ITS CORPORATION			REV	ECN	DATE	APV
THIS PRINT IS THE PROPERTY OF ITS CORP. IT SHALL NOT BE COPIED WITHOUT PERMISSION.			TITLE			
			SCHMEMATIC, AMP./ATTENUATOR MODULE MMDS (1132-1509)			
MATERIAL			DWN	JCM	11/21/91	DWG. NO.
FINISH			CHK	JCM	11/14/91	1132-3509
			REL	JCM	11/14/91	REV
			SCALE ---		SHEET 1 OF 1

ITS CORPORATION				REV	ECN	DATE	APV
REV	ECN	DATE	APV	THIS PRINT IS THE PROPERTY OF ITS CORP. IT SHALL NOT BE COPIED WITHOUT PERMISSION.			
				MATERIAL			
				FINISH			
TITLE				SCHEMATIC – BROAD BAND CAVITY FILTER, 3 SECTION (1107–1101)			
DWN		JEO	6/27/88	DWG. NO.		REV	
CHK		RE	6/29/88	1107–3101		0	
REL		RE	6/29/88	A	SCALE ---	SHEET 1 OF 1

ITS CORPORATION				REV	ECN	DATE	APV
THIS PRINT IS THE PROPERTY OF ITS CORP. IT SHALL NOT BE COPIED WITHOUT PERMISSION.				TITLE SCHEMATIC - TRANSMITTER CONTROL BD. (1510-1104)			
				DWN	KEF	3-28-94	DWG. NO.
MATERIAL				CHK	CAR	5/10/94	1510-3104
FINISH				REL	KEF	11/17/94	2
				SCALE ---		SHEET 1 OF 1

TITLE										SCH., DUAL AVERAGE DETECTOR (1510-1105)									
DWN		KEF		3/28/94		DWG. NO.						REV							
CHK		CAR		5/10/94		1510-3105						3							
REL		KEF		11/17/94		B		SCALE- -				SHEET 1 OF 1

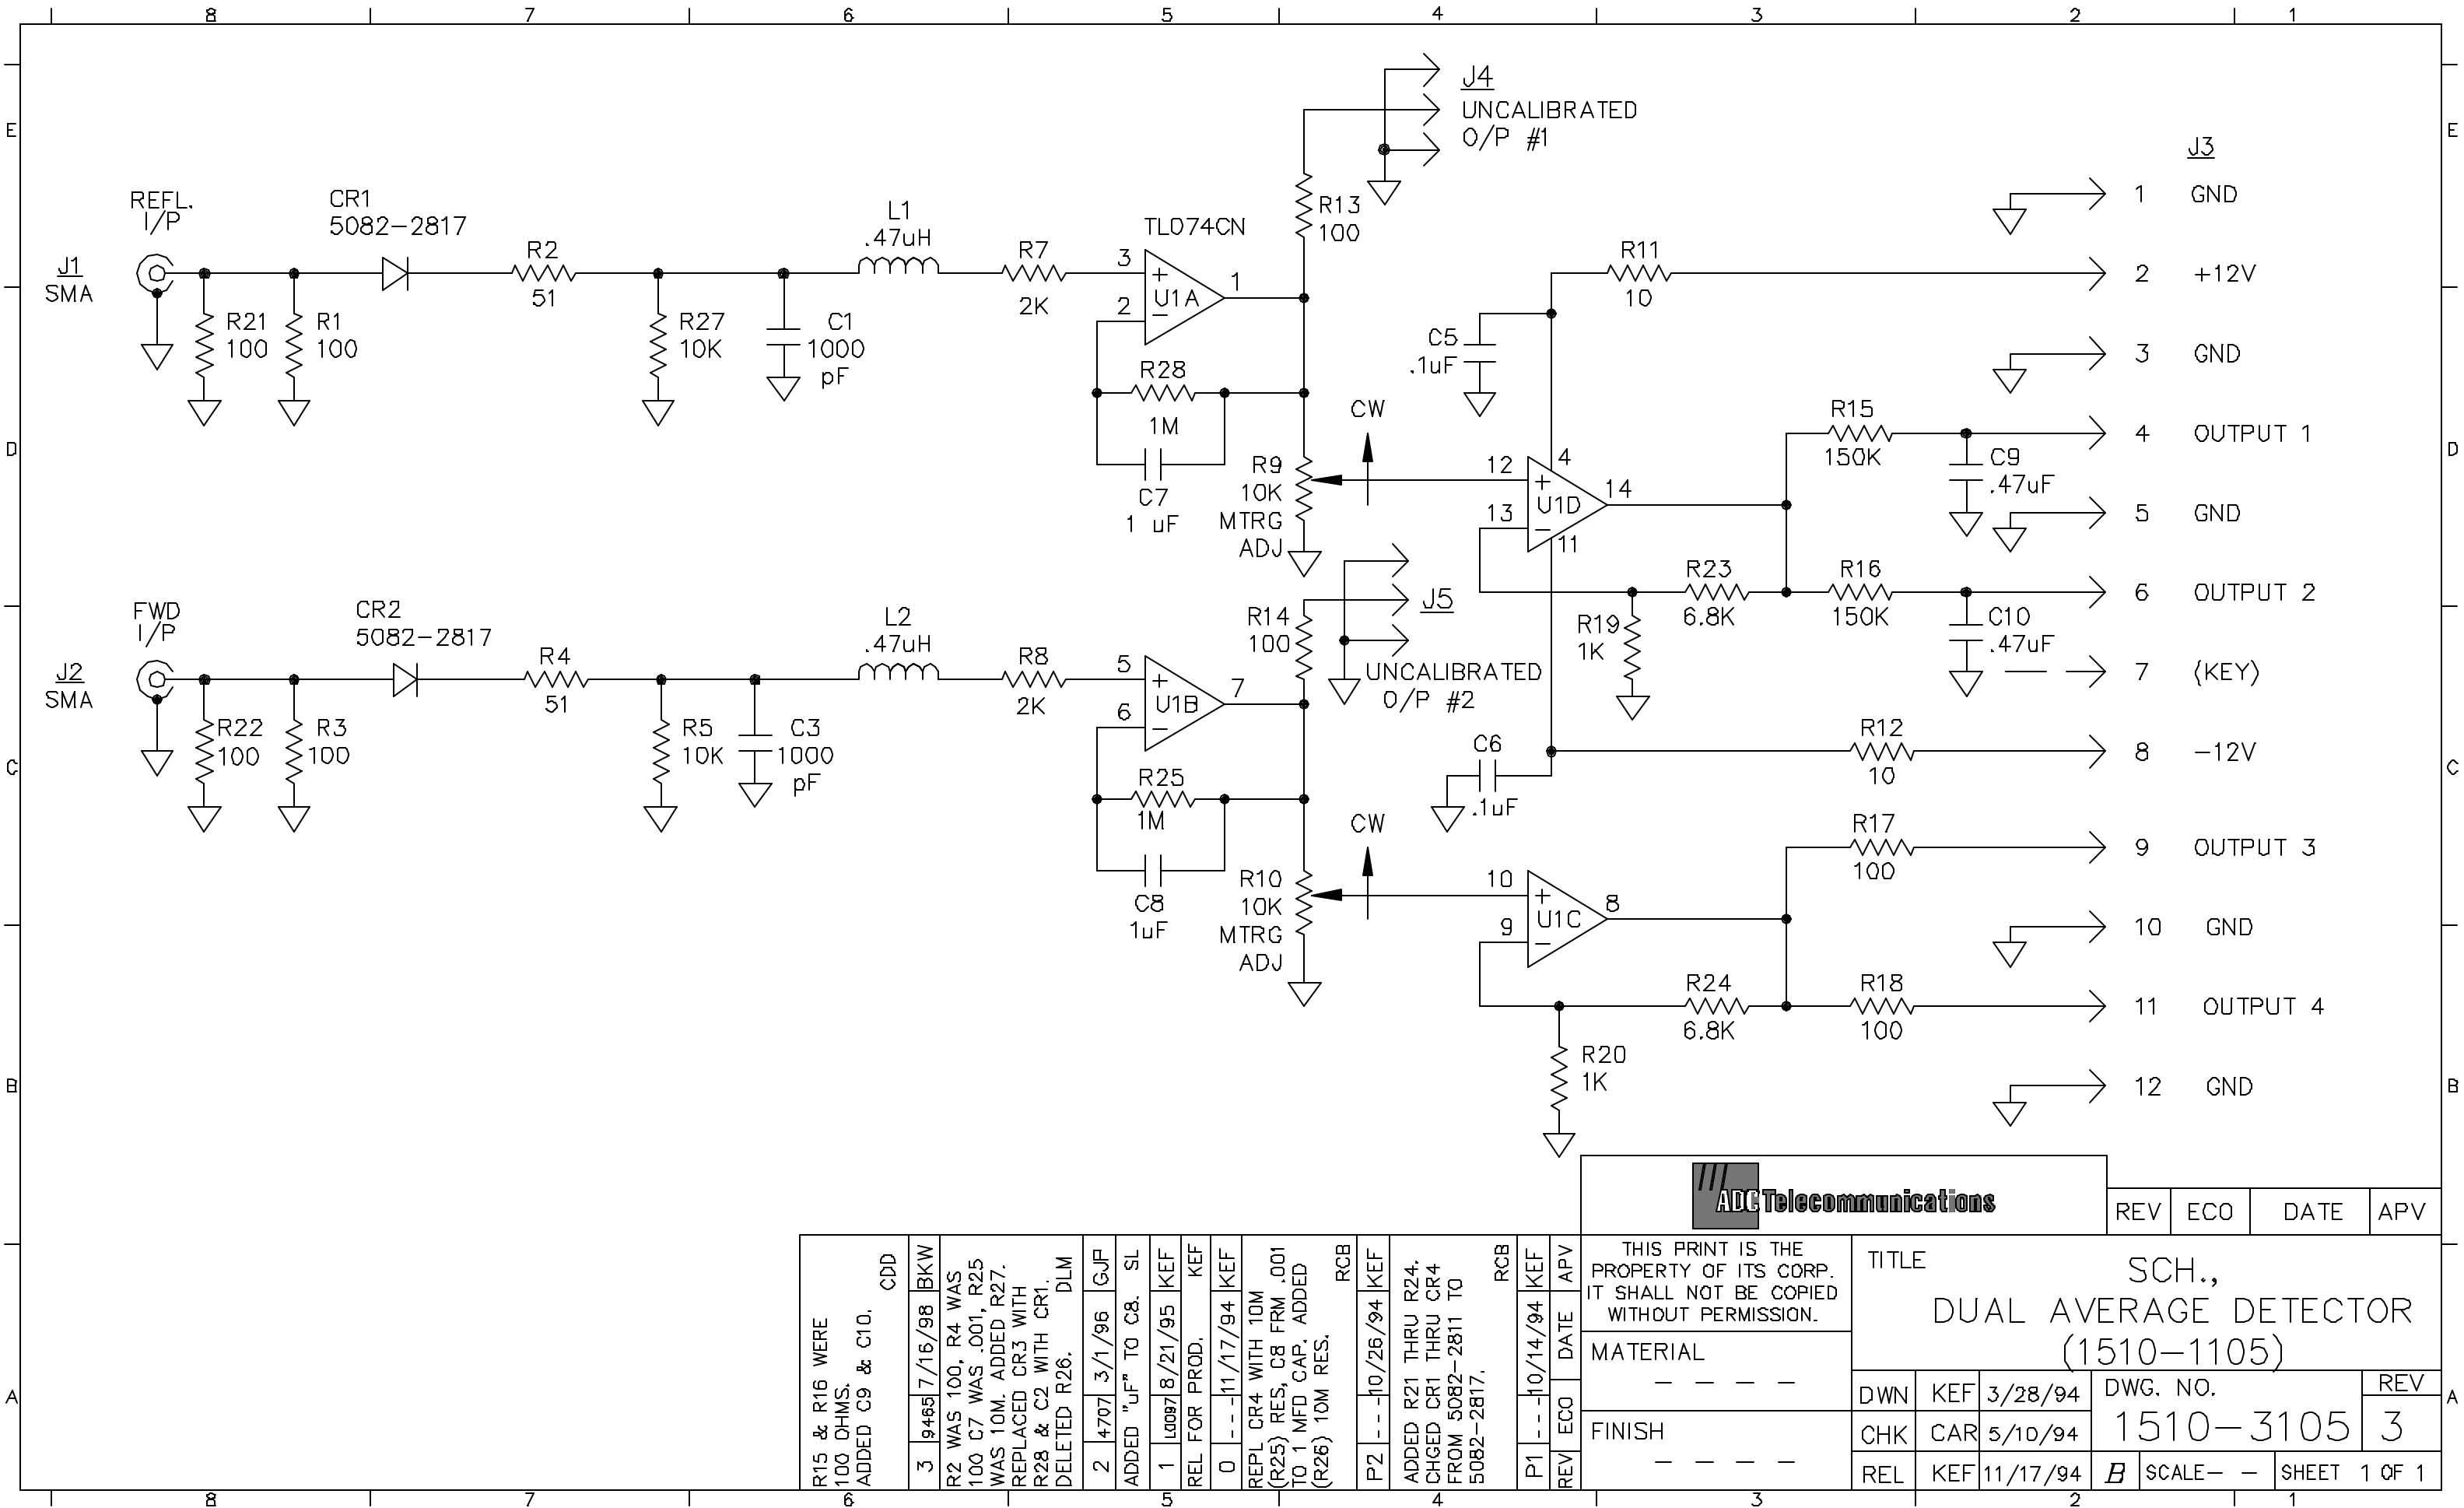
R15 & R16 WERE 100 OHMS. ADDED C9 & C10. CDD				3	9465	7/16/98	BKW	R2 WAS 100, R4 WAS 100 C7 WAS .001, R25 WAS 10M. ADDED R27. REPLACED CR3 WITH R28 & C2 WITH CR1. DELETED R26. DLM				2	4707	3/1/96	GJF	SL	ADDED "UF" TO C8. SL				1	10087	8/21/95	KEF	KEF	REL FOR PROD. KEF				0	--	--	11/17/94	KEF	REPL CR4 WITH 10M (R25) RES, C8 FRM .001 TO 1 MFD CAP. ADDED (R26) 10M RES. RCB				P2	--	--	10/26/94	KEF	ADDED R21 THRU R24. CHGED CR1 THRU CR4 FROM 5082-2811 TO 5082-2817. RCB				P1	--	--	10/14/94	KEF	APV
---	--	--	--	---	------	---------	-----	--	--	--	--	---	------	--------	-----	----	----------------------	--	--	--	---	-------	---------	-----	-----	-------------------	--	--	--	---	----	----	----------	-----	--	--	--	--	----	----	----	----------	-----	--	--	--	--	----	----	----	----------	-----	-----

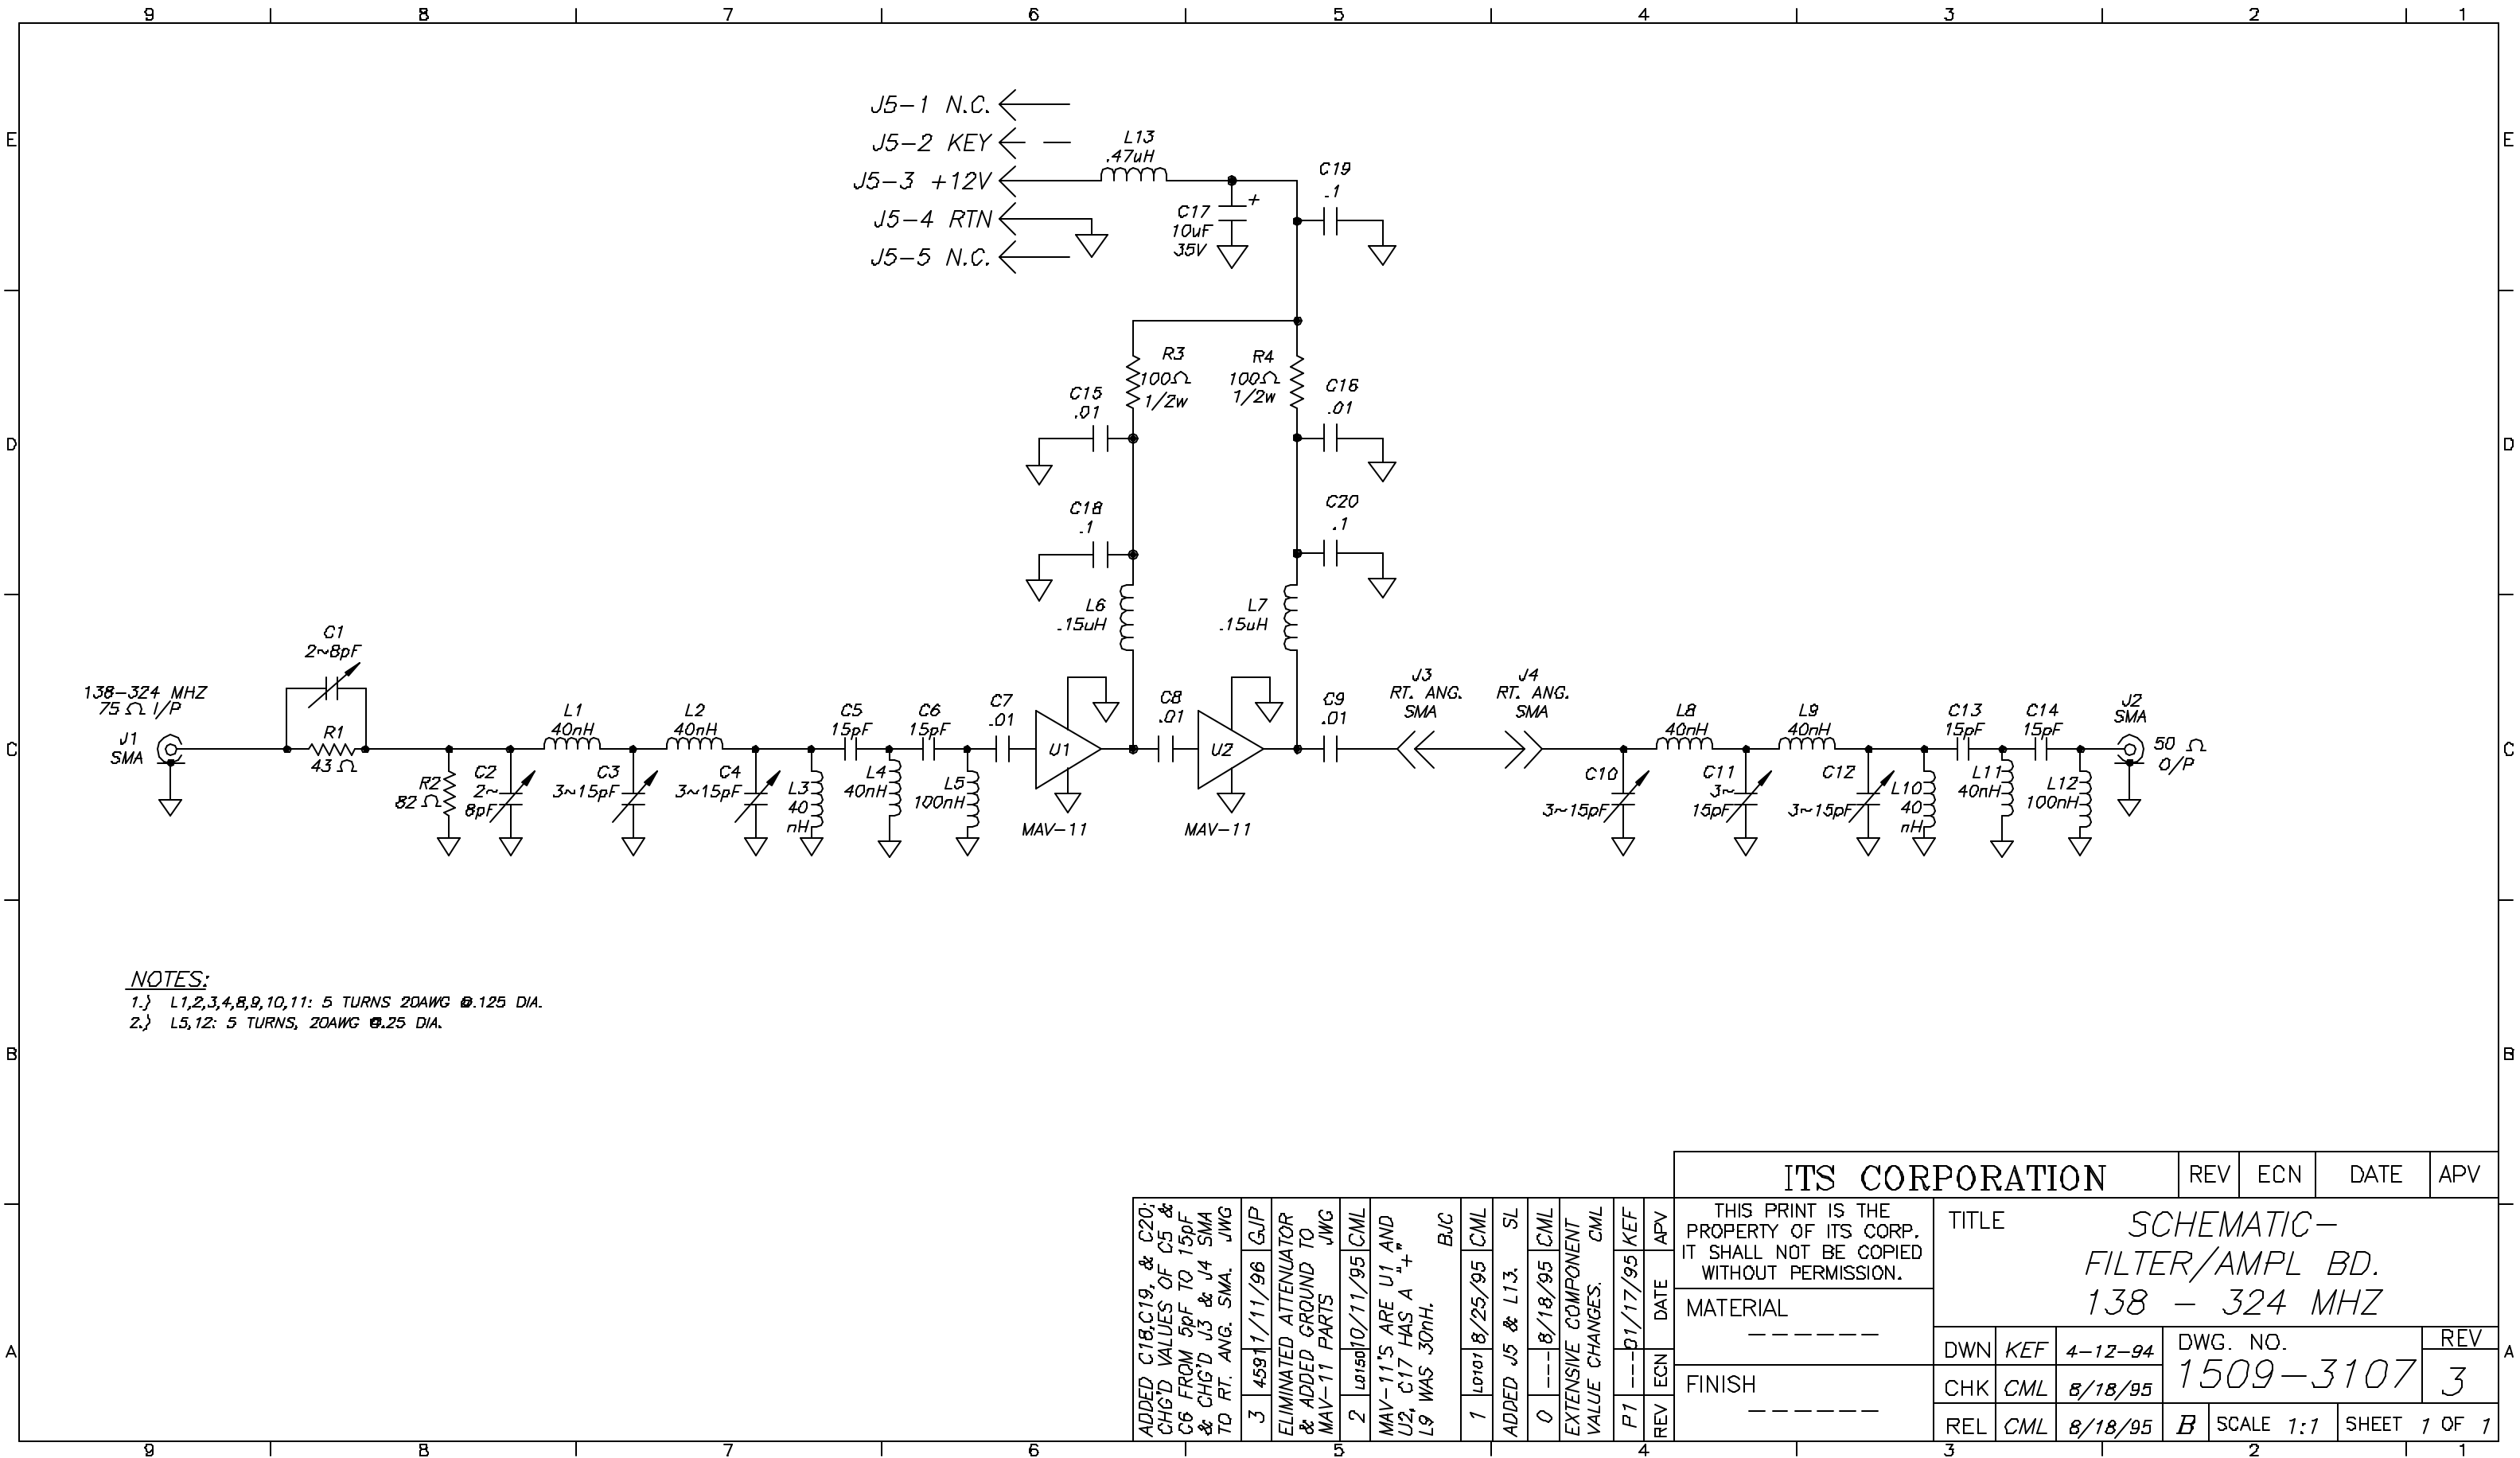
ADDED C18,C19, & C20: CHG'D VALUES OF C5 & C6 FROM 5pF TO 15pF & CHG'D J3 & J4 SMA TO RT. ANG. SMA. JWG		3	459	11/11/96	GJP
		ELIMINATED ATTENUATOR & ADDED GROUND TO MAV-11 PARTS JWG			
		2	10150	10/11/95	CML
		MAV-11'S ARE U1 AND U2, C17 HAS A "+" L9 WAS 30nH. BUC			
ADDED J5 & L13. SL		1	10101	8/25/95	CML
		0	---	8/18/95	CML
		EXTENSIVE COMPONENT VALUE CHANGES. CML			
		P1	---	01/17/95	KEF
REV	ECN	DATE	APV
